Form C-103
Revised July 18, 2013

WELL API NO. 30-015-41691
5. Indicate Type of Lease STATE ☒ FEE ☐
6. State Oil & Gas Lease No.
7. Lease Name or Unit Agreement Name Anthill State SWD
8. Well Number 005
9. OGRID Number 308339
10. Pool name or Wildcat SWD;DEVONIAN

Plug And Abandonment Procedure

Anthill State #005

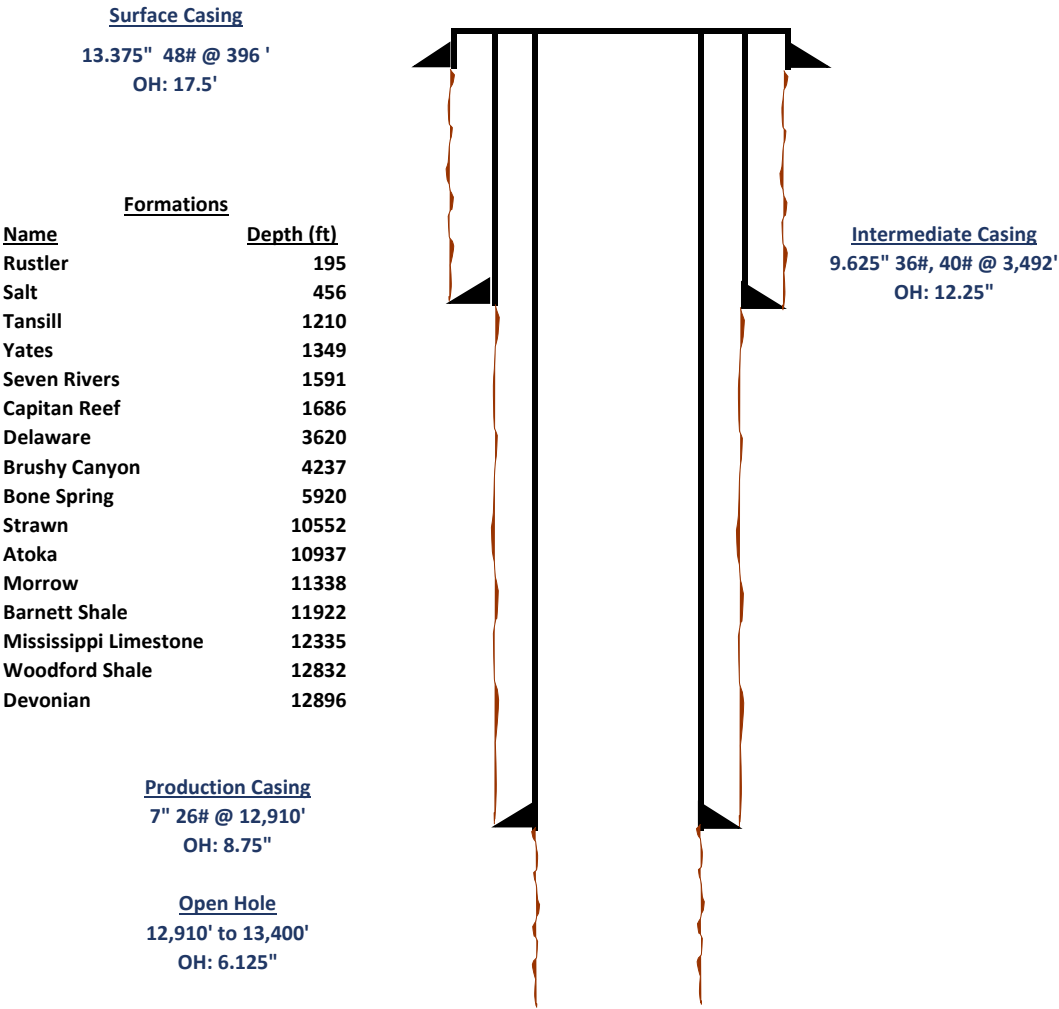
See Changes to plugging plan

Spot 25 sx cmt 11388' - 11288' - T Morrow

Spot 25 sx cmt 10987' - 10887' - T Atoka

Spot 25 sx cmt 10600' - 10500' - T Strawn

Spot 25 sx cmt 9450' - 9350' - T Wolfcamp

Spot 25 sx cmt 7000' - 6900' - mandatory spacer
